# memorandum

date March 6, 2018  
to Vera Koliass, AICP (City of Milwaukie)  
from John Vlastelicia  
subject Natural Resource Review for Ledding Library Construction Project  
10660 SE 21st Avenue (Assessor Map 11E36BB, Tax Lot 1800)  
City of Milwaukie Land Use File #CSU-2018-002

PHS Report Figure 3 (Existing Conditions)

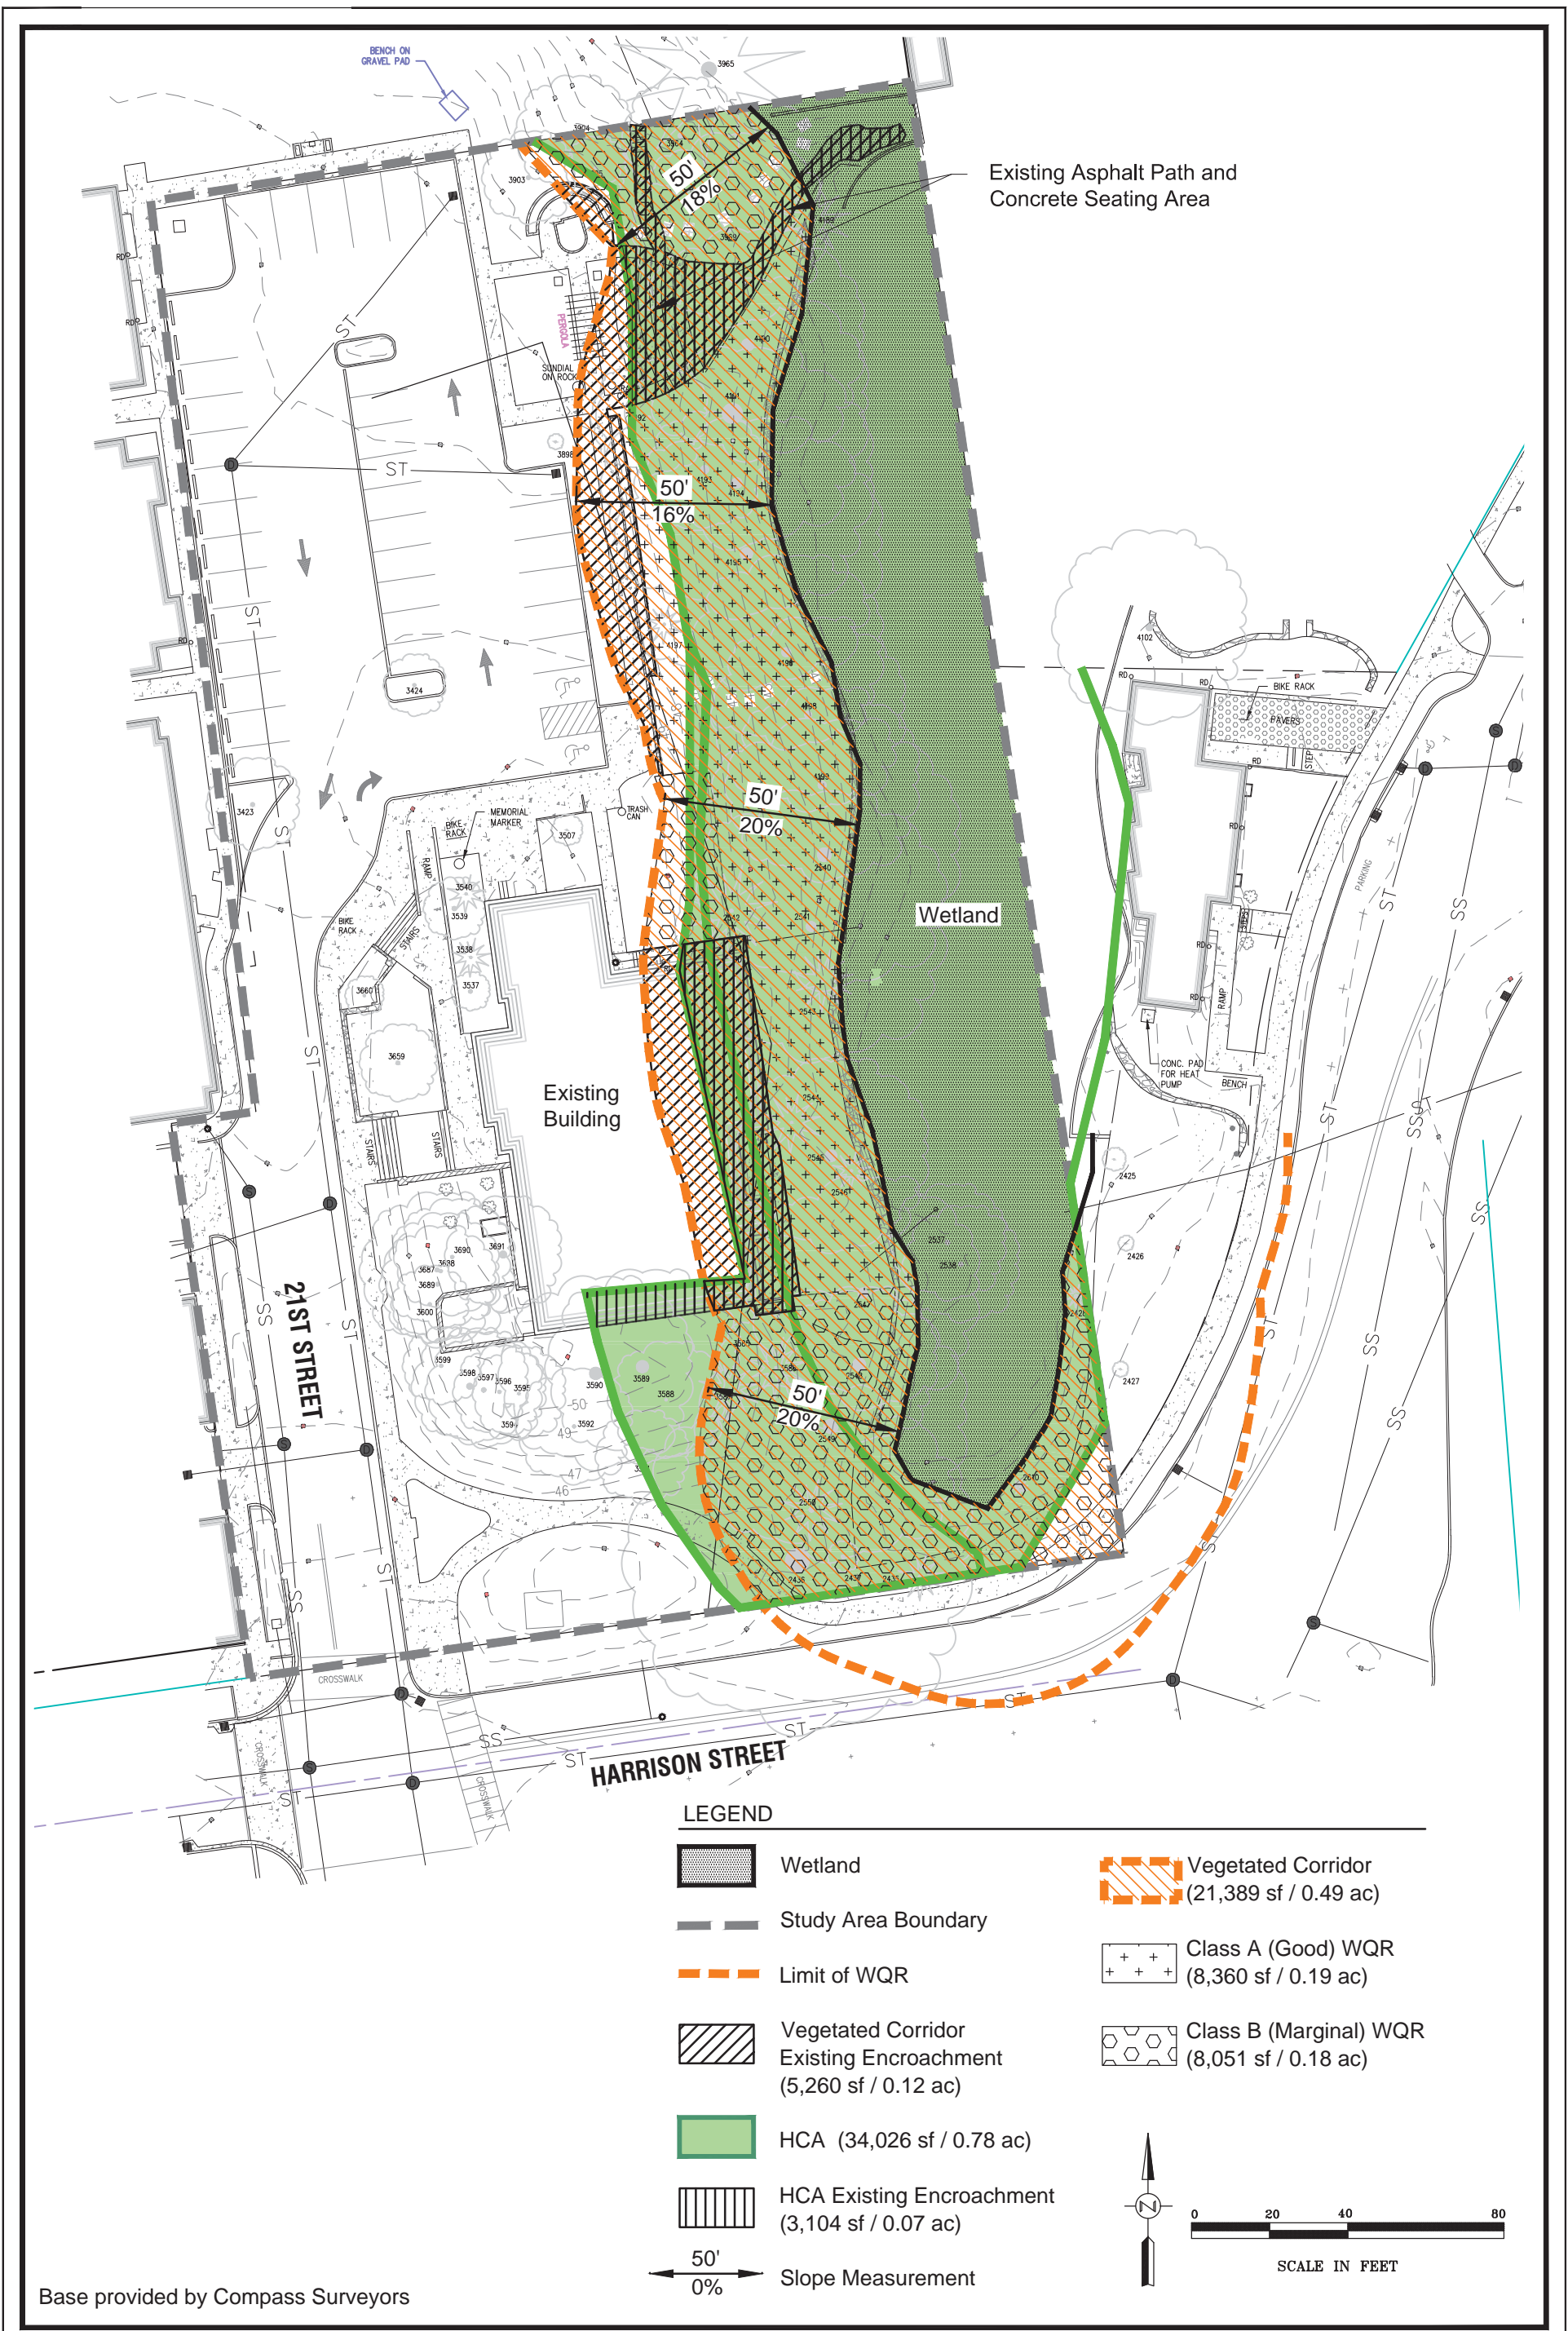
The PHS report Figure 3 (and other PHS report figures) does not distinguish Spring Creek from its adjacent wetland; the entire feature is simply labeled “Wetland” and there is no label on any PHS report figure that identifies Spring Creek. While some reference to Spring Creek on the figures would be helpful, the lumping of Spring Creek (below ordinary high water) with its adjacent wetland (above ordinary high water) into a single “Wetland” feature representing the Primary Protected Water feature is acceptable for establishing the adjacent vegetated corridor and thus the WQR regulated by MMC.

- PHS and Apex Wetland Boundary Difference: The “Wetland” boundary shown in PHS report Figure 3 does not appear to exactly match the wetland boundary shown in the Apex Wetland Delineation Report Figure 6, even though the PHS report text suggests that they are the same. Both figures are attached to this memorandum for reference.

It appears that the western “Wetland” boundary line shown in the PHS report figures generally follows the toe of a rock retaining wall that meanders in a north-south direction through the eastern portion of the site, while the Apex report Figure 6 shows a more complex boundary that likely differentiates wetland and non-wetland areas below the rock retaining wall. Also, the Apex report does not show a stream/wetland boundary extending beyond (north of) the asphalt-path crossing of the water feature on the northern portion of the site, while the PHS report figures show the wetland/stream extending through that area and encompassing the asphalt path.

- Vegetation Inventory: Tables 1, 2, and 3 of the PHS report list plant species and percent cover from three sample points in the vegetated corridor. The sample point locations are not identified on the report's Figure 3 (they should be), but the species noted in the report tables and described elsewhere in the report text are generally consistent with vegetation conditions as ESA staff observed during our February 23 site visit. ESA noted that many of the young native trees in the understory of the corridor, including a number of western redcedar, appear to have been planted.

By drawing a “Wetland” boundary along the retaining wall and extending that boundary through the asphalt path that crosses the stream in the north portion of the site, the PHS report takes a conservative approach to defining the Primary Protected Water Feature and thus establishes a vegetated corridor offset and a WQR that maximize resource protections. For that reason, the wetland boundary discrepancies between the PHS report figures and Apex report figures do not impact the overall review of the proposal.

SITE SURVEY AND EXISTING STREET VIEW KEY

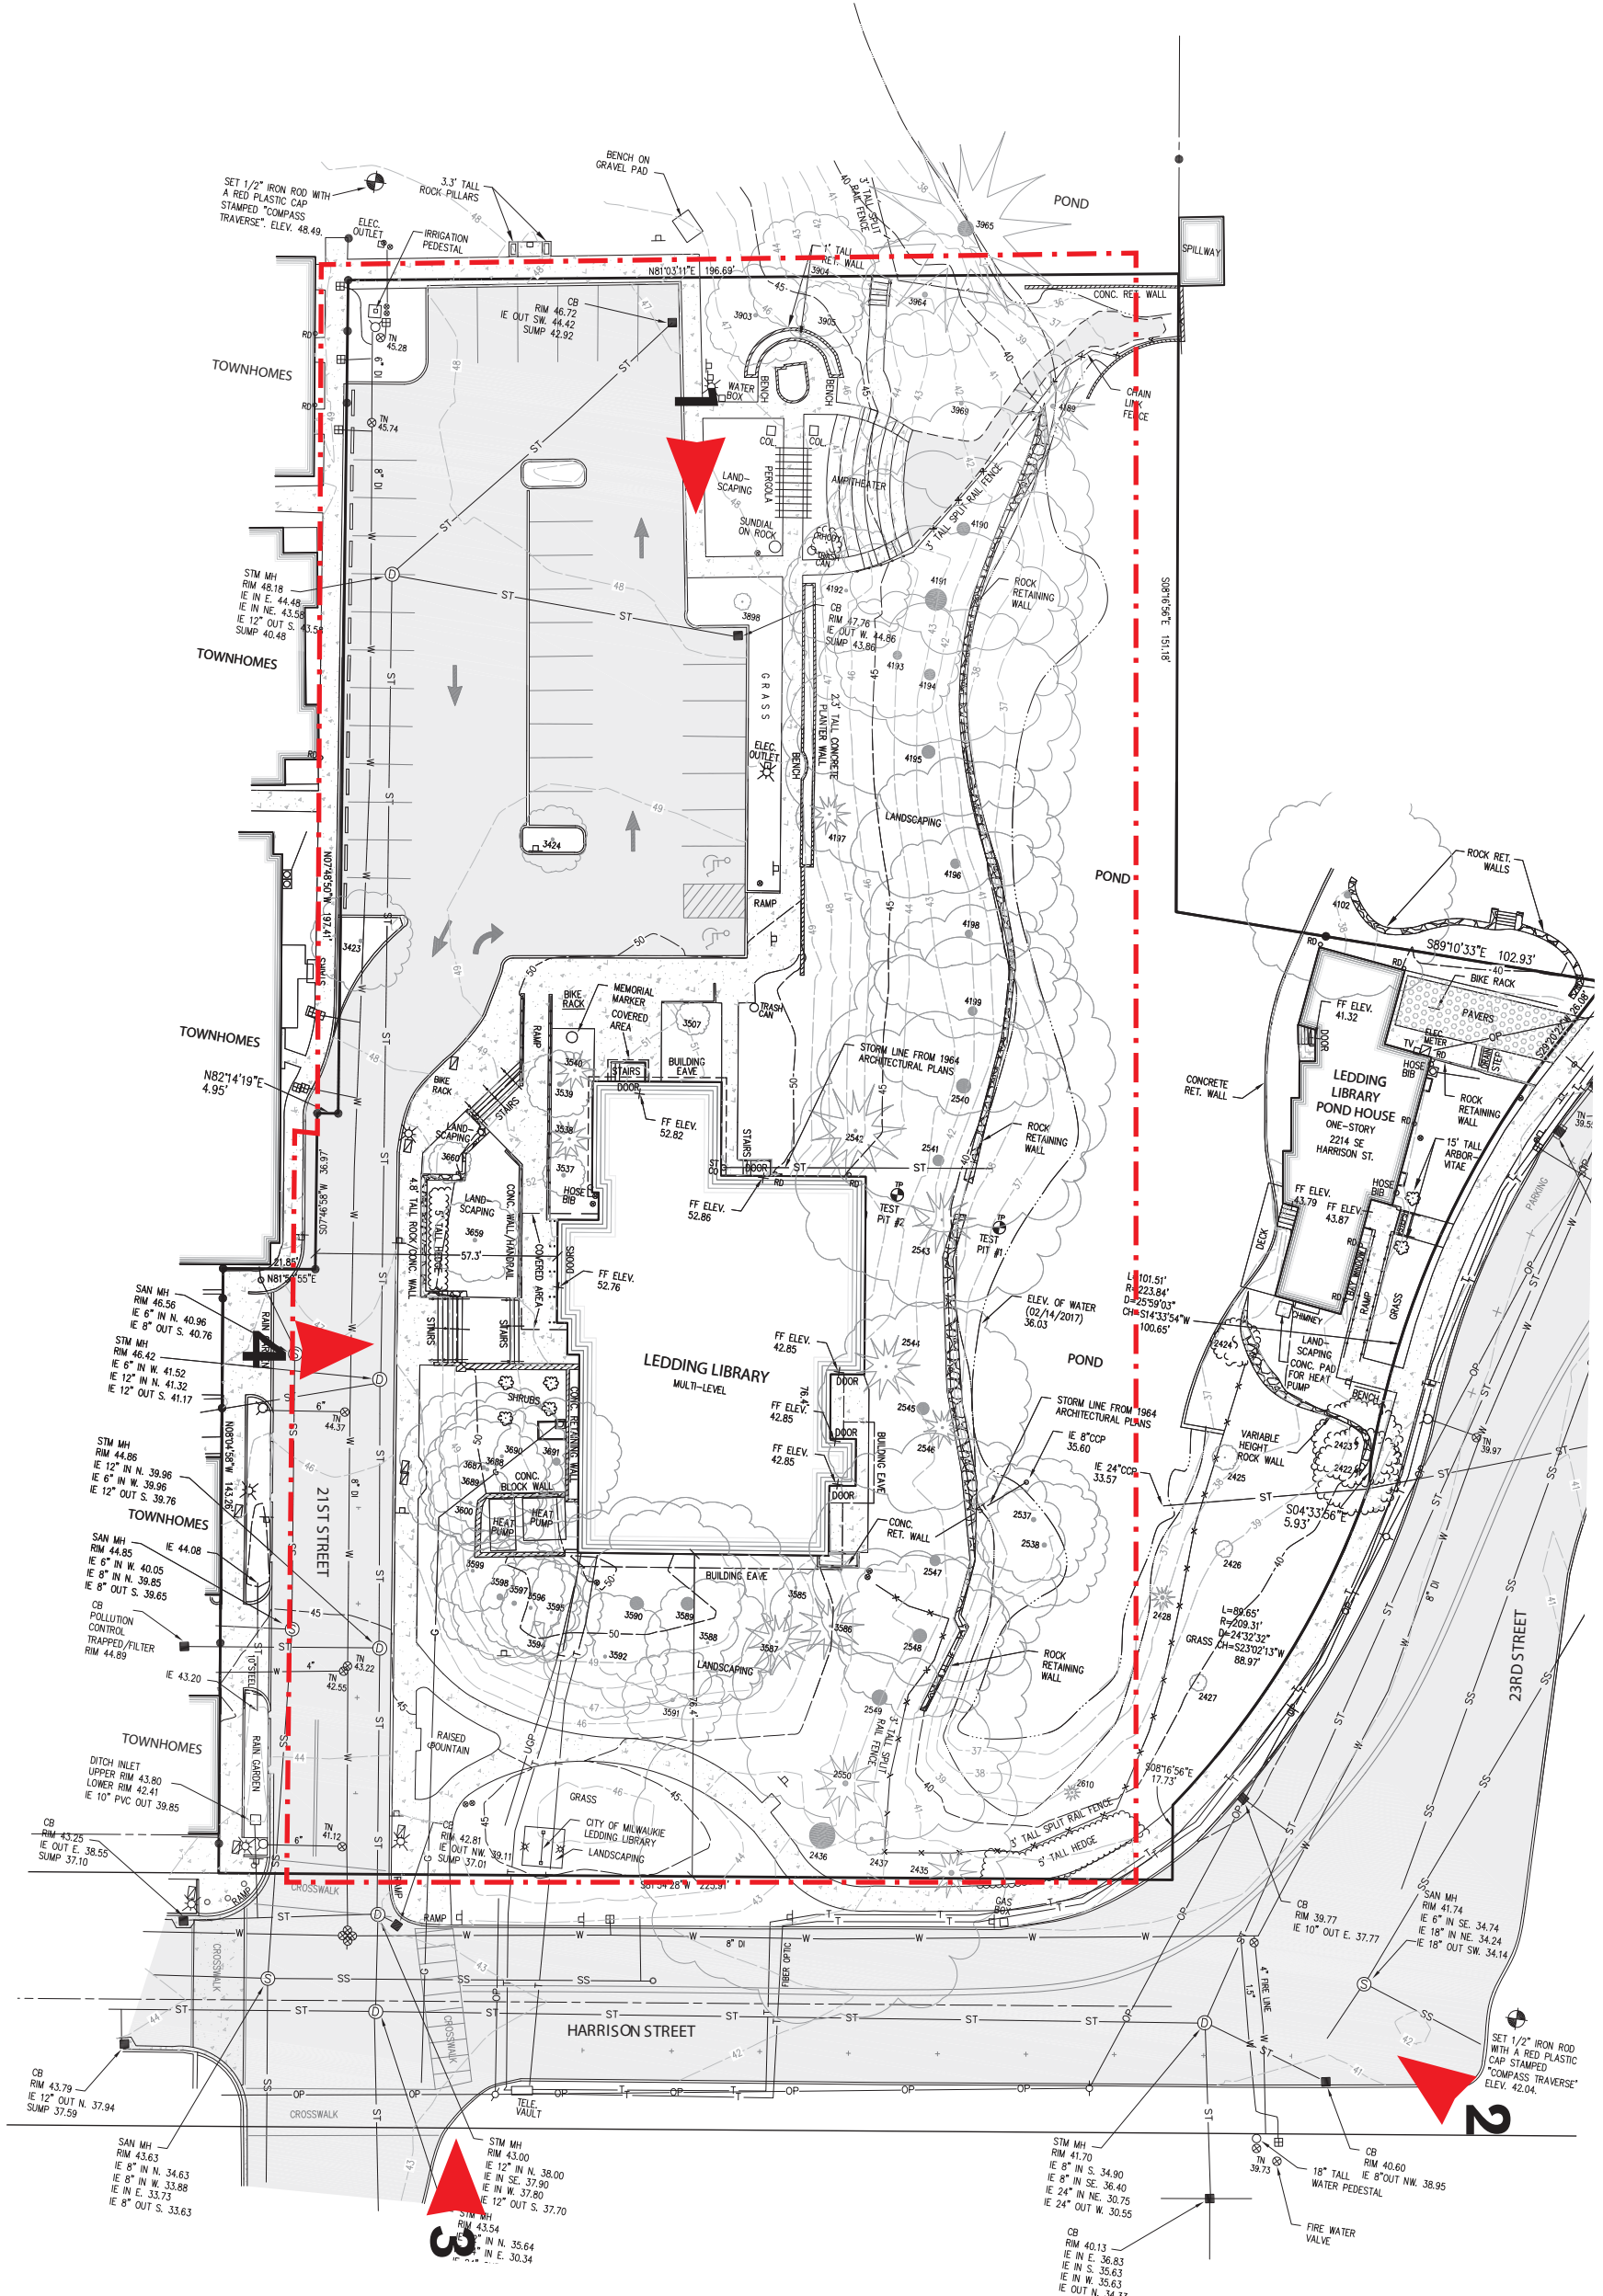
During the site visit, ESA staff observed the rock retaining wall, which is shown and labeled on the existing conditions survey included in the land use application and attached to this memorandum for reference. The retaining wall represents a sharp topographic break that functionally separates the lower Spring Creek/wetland/floodplain area from the upland slopes of the adjacent riparian forest, and there is logic in using the retaining wall as the approximate boundary line separating the Primary Protected Water Feature from its adjacent Vegetated Corridor.

- Vegetated Corridor Width: The topographic survey included in the land use application and attached to this memo shows 1-foot contours for the site, including the area of the Vegetated Corridor. The survey and field observations made by ESA staff indicate that the slopes adjacent to the Wetland are less than 25%, and so the 50-foot vegetated corridor width shown on the PHS report figures is appropriate.
